CERTIFICATE OF APPROPRIATENESS

Property: 1973 Gray Street, Tract 9, Montrose Subdivision. The property includes a historic 76, 340 square foot commercial/retail center situated on a 111,122 square foot lot.

Significance: River Oaks Theatre and Shopping Center is a City of Houston Landmark designated in August 2007. The two-story historic commercial structure includes a movie theatre and several one- and two-story, stucco-clad buildings that were constructed circa 1936-37.

Recommendation: Denial - does not satisfy criteria

Front Façade – Existing

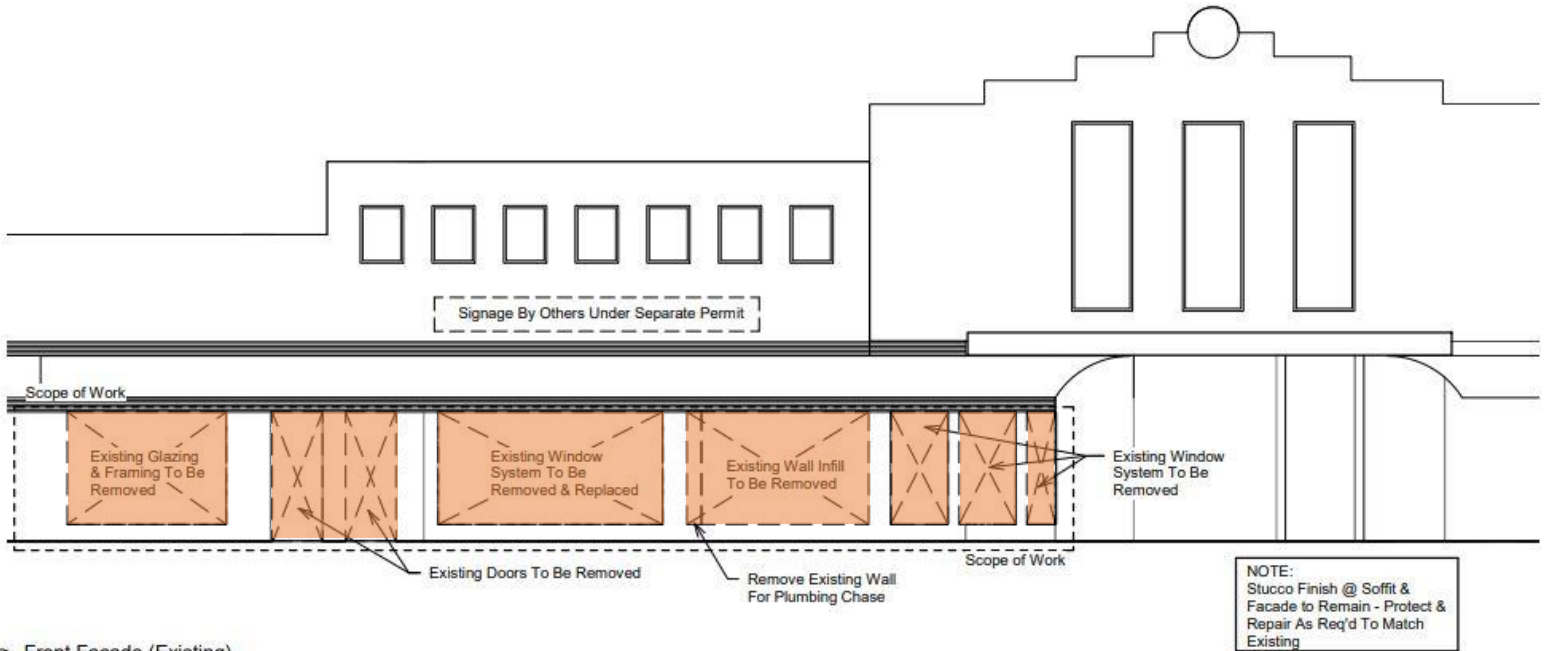
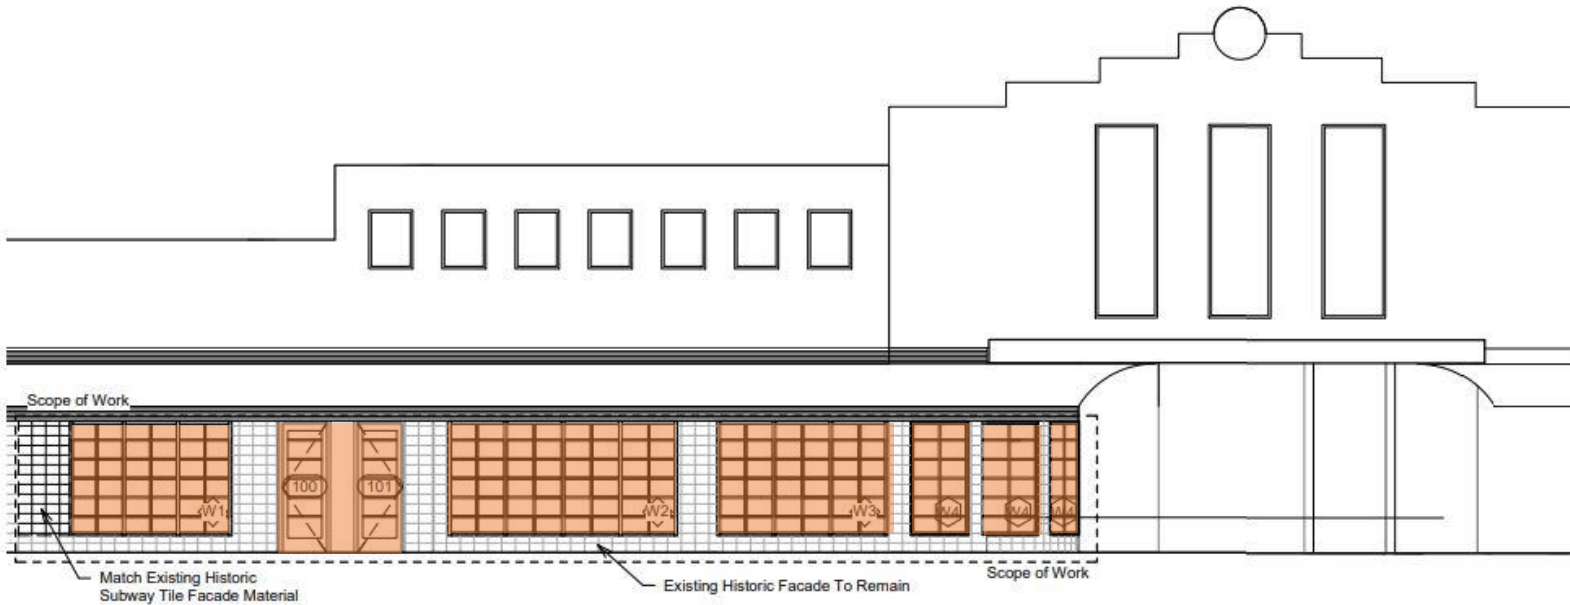
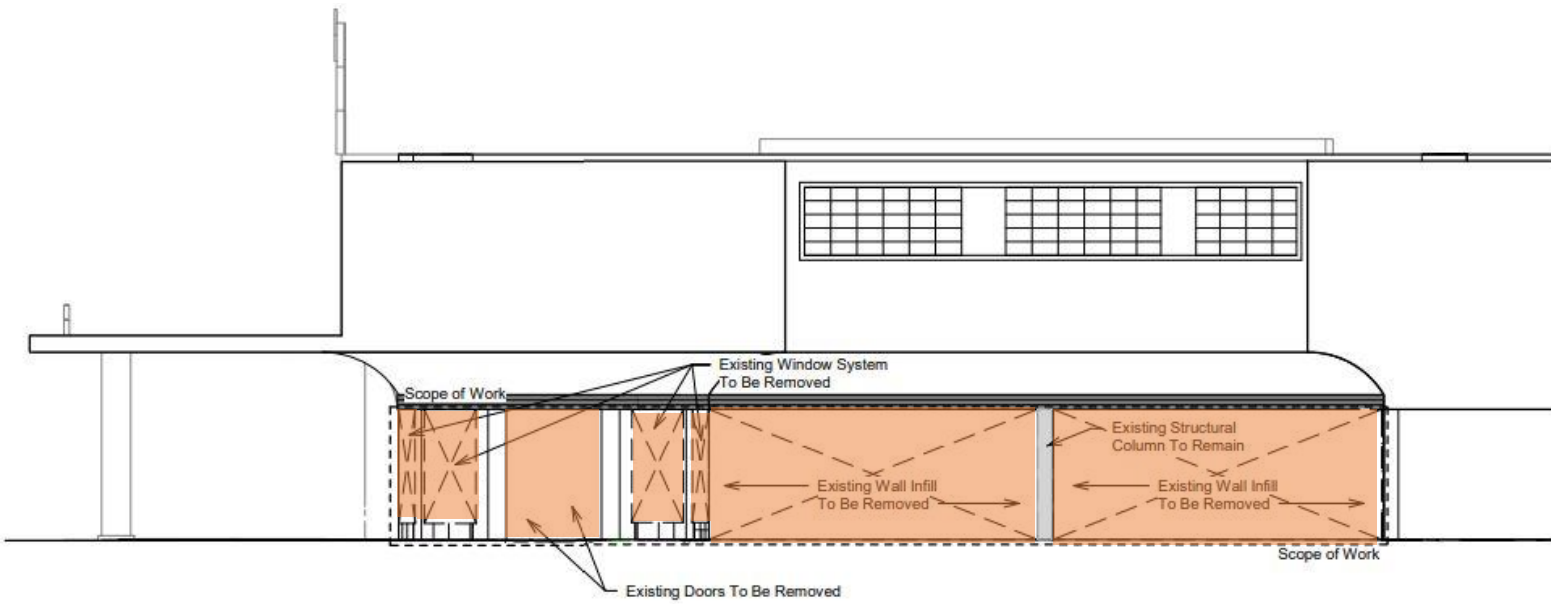
- Front façade-remove existing wall infill and install 11'8"x7'10" aluminum window, recessed 4", and a 6-over-6 lite pattern
- Atrium façade- two existing, non-historic windows to be replaced with aluminum windows, recessed 4", with 2-over-6 lite pattern

| <input type="checkbox"/> | <input checked="" type="checkbox"/> | <input type="checkbox"/> | (4) The proposed activity must preserve the distinguishing qualities or character of the building, structure, object or site and its environment; Wall sections proposed for replacement with windows appear to be original and are a character-defining feature. |

⑤ Atrium Facade (Proposed)
1/8" = 1'-0"

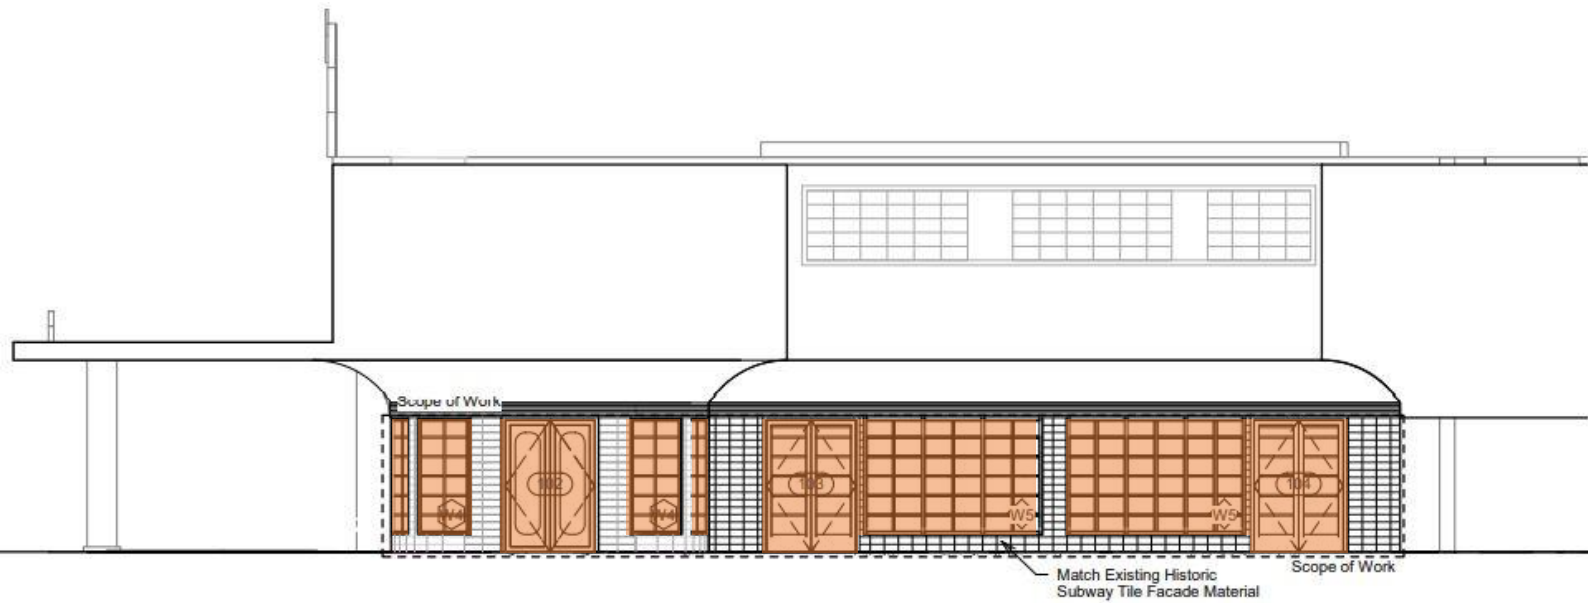
- Atrium façade-existing doors to be replaced with aluminum doors having a black anodized finish
- Atrium façade-remove existing wall infill and install two 12'x7'10" aluminum windows, recessed 4", with 6-over-6 lite patterns

- Atrium façade-remove existing wall infill and install two sets of aluminum doors having a black anodized finish measuring 8'10"x6'
- Rear façade-remove existing glass block and install a single, aluminum door with 1-over-6 lite pattern measuring 8'10"x3'.
